REQUEST

Current Zoning: R-12MF(CD) (Multi-Family Residential, Conditional)
Proposed Zoning: N2-A(CD) (Neighborhood 2-A, Conditional)

Approximately 3.16 acres located west of Marsh Road, south of Auburn Avenue, and east of Hartford Avenue.

The petition proposes the development of up to 37 multi-family attached units. The site is currently developed with a medical office.

PLANNING STAFF REVIEW

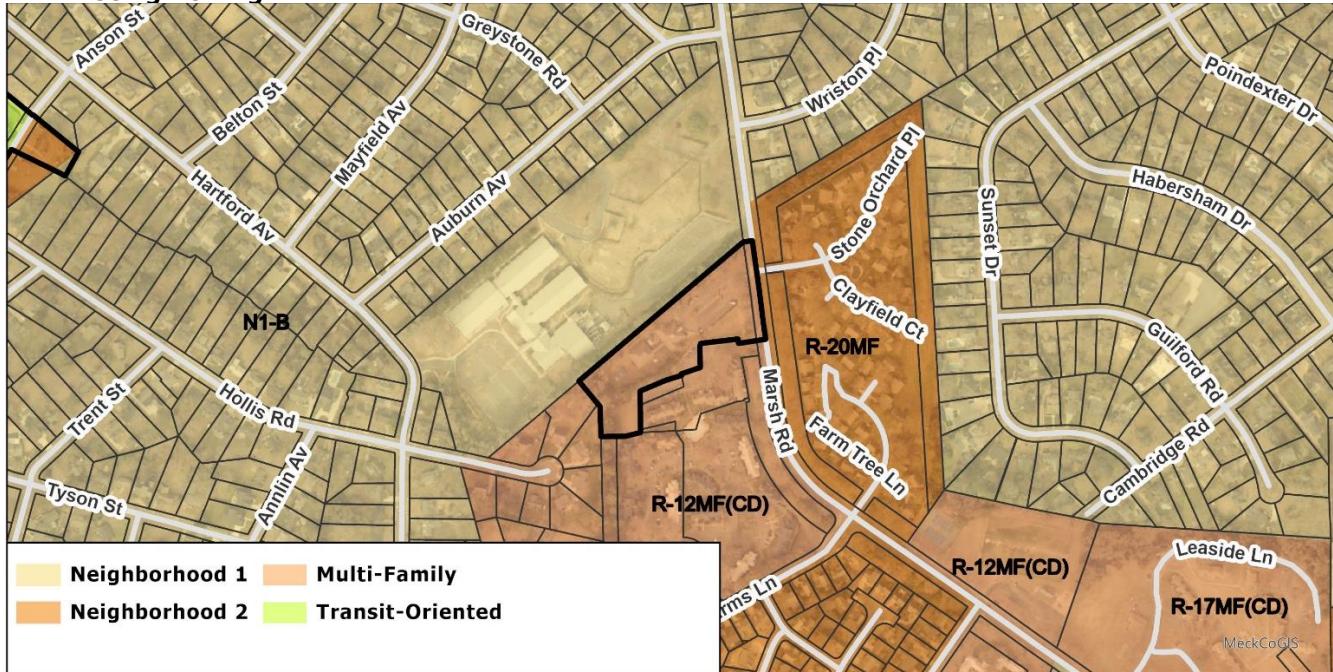
1. ~~CDOT: Revise site plan and conditional note(s) to clarify a 40' vehicle turn around between gated entrance and back of sidewalk.~~

2. ~~Fire: Must be a minimum width of 20 feet for undivided entry/exit or 16 feet for divided entry/exit.~~ **ADDRESSED**

3. ~~Fire: All gates shall have a Knox Box or Knox Switch for fire department access.~~ **ADDRESSED**

4. ~~Fire: Electric gate operators, where provided, shall be listed in accordance with UL 325. Gates intended for automatic operation shall be designed, constructed, and installed to comply with the requirements of ASTM F2200~~ **ADDRESSED**

5. ~~Entitlement Services: There is an approximately 60' berm along the front of the property. Adjust the site design to be consistent with existing development along Marsh Road which incorporates large setbacks.~~ **ADDRESSED**

6. ~~Entitlement Services: Please specify what type of open space is being proposed.~~ **ADDRESSED**

7. ~~Urban Design: Expand the footprint of open space and increase minimum open space dimension. The allocation of 10' in front of the units for open space is narrow and will not be ample to program or activate with quality open space.~~ **ADDRESSED**

8. ~~Urban Forestry: Replanted tree save is not a default option and some preservation is required.~~ **OUTSTANDING**

9. ~~Urban Forestry: When using the drip line of heritage tree or specimen trees, the actual drip line must be used, not just an area based on tree diameter. This area must also be protected in order to qualify.~~ **OUTSTANDING**

10. ~~Urban Forestry: Protected tree save must be a min of 30' wide.~~ **OUTSTANDING**

11. ~~Urban Forestry: There is a 10' no build zone around tree save area. This would apply to buildings and wall/enclosures.~~ **OUTSTANDING**

12. ~~Urban Forestry: Utilities are not permitted within tree save areas.~~ **OUTSTANDING**
